## **Board of Selectmen**

The Buxton Board of Selectmen is submitting the following comments concerning the Draft Study Plan for the Decommissioning of the Bar Mills Hydroelectric Project (FERC No. 2194). The basis of the comments are the selectboard's responsibility to "protect the health, safety, and welfare of the Town's residents."

Figure 1

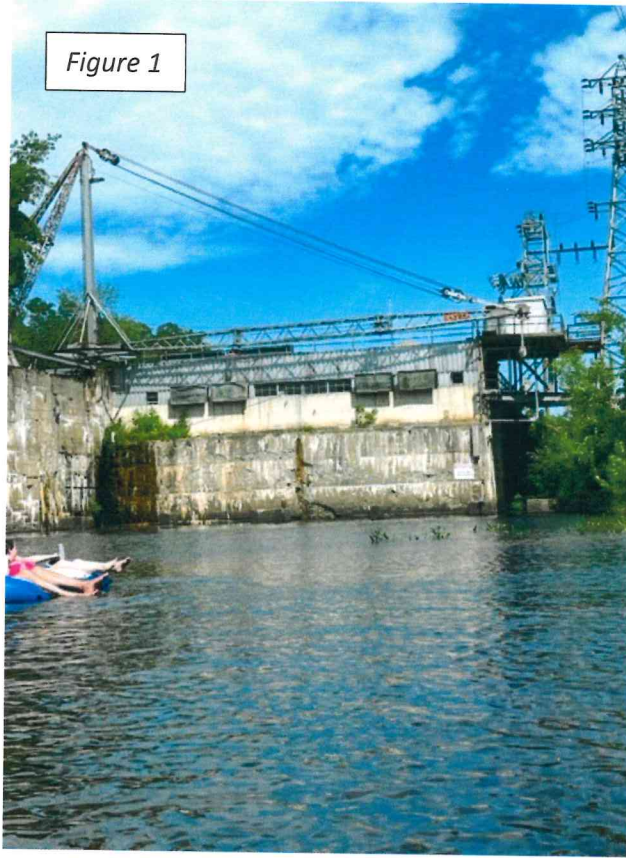
The proposed methodology to assess aesthetics (7.7.6) will not fully address the concerns of local property owners and the communities of Hollis and Buxton. Figure 1 shows the weathering concrete on the downstream side of the powerhouse. Figure 2 shows the powerhouse as viewed from private property in Buxton. A winter view of the abandoned Rogers Fibre Mill from the Bar Mills Bridge (Figures 3) shows

1. What will be the aesthetics of the Project area from vantage points on private or public properties in addition to the boat launch and Bar Mills Bridge?
2. How will the aesthetics change as the remaining structures degrade over time?
3. What will be the aesthetics of the Project area in winter versus summer?
4. What will be the cumulative effect of the remains of two bridges, the spillway dam and its sluice, the timber crib dam, the mill, the powerhouse dam, and the powerhouse on aesthetics?

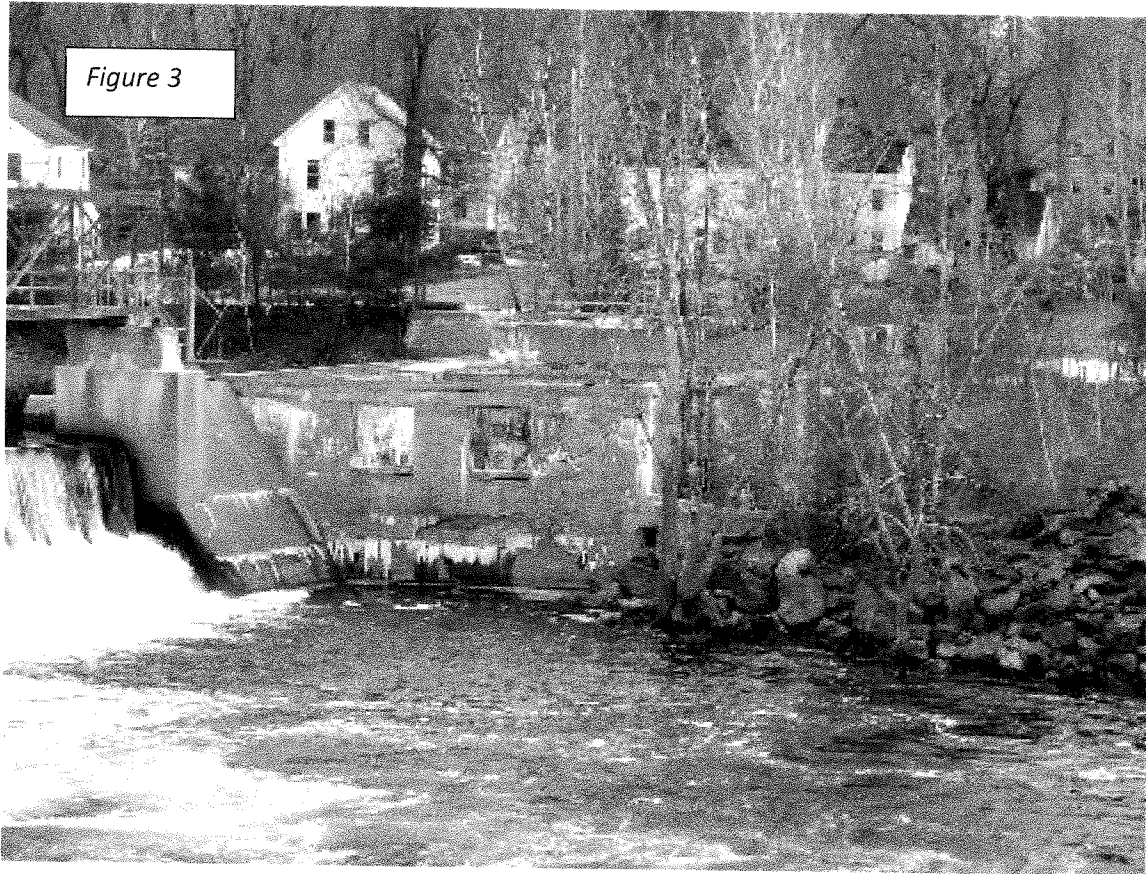
its deteriorating foundation.
